UNITED STATES ENVIRONMENTAL PROTECTION AGENCY
REGION 7

RE: Ag Processing, Inc., Hastings Soybean Processing Plant draft Prevention of Significant Deterioration permit comments

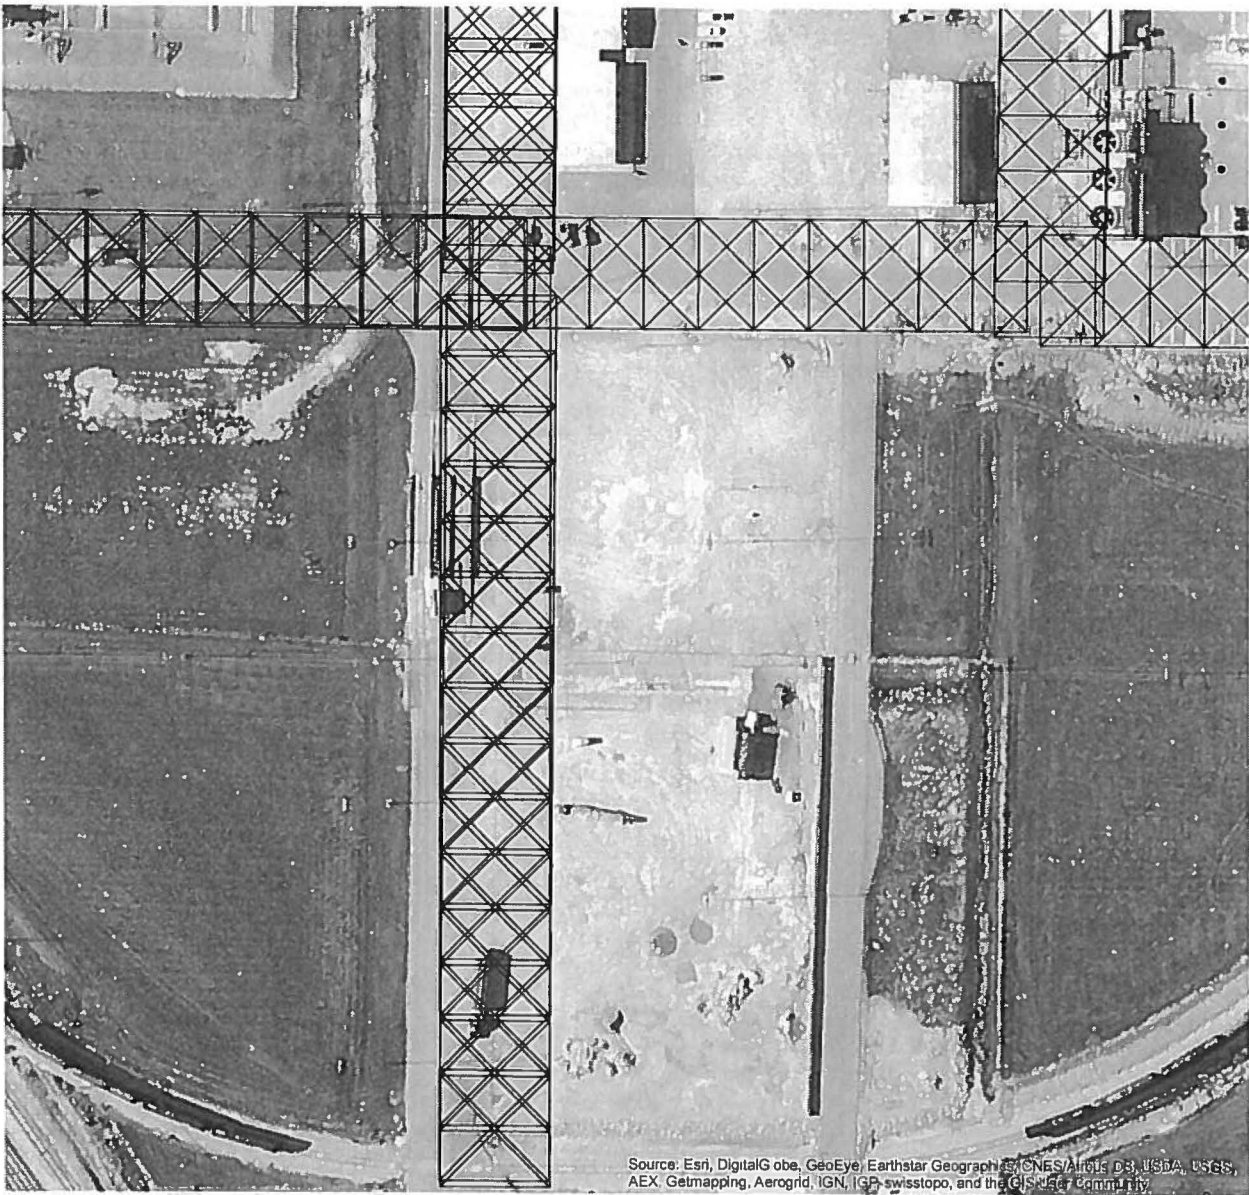
In addition the maximum legal vehicle width in Nebraska is 8.5 ft (2.59 meters). Following the haul road guidance document the width of the plume would be $VW + 6m$ for single lane roadways or $Road\ Width + 6m$ for two lane roadways, which equates 8.59 meters for a single lane road. NDEQ is using 26.6 meters for the plume width indicating a road width of 20.6 meters or 67.6 feet. Haul roads 67.6 ft wide seem unlikely in this case. In addition, the two lane calculation is generally used for a heavily traveled divided road, which seems unlikely in this case.

Finally, the initial lateral dimension appears to have been calculated by dividing the length of the side by 4.3. The 4.3 factor is used to represent a single volume source. In this case, for a haul

road, the volumes are being used to represent a line source, the road, and the initial lateral dimension should be equal to the length of the side divided by 2.15. This lateral dimension calculation can also be found in the haul road guidance document.

NDEQ should consider modifying the haul road modeling to conform to the Haul Road Workgroup final report.
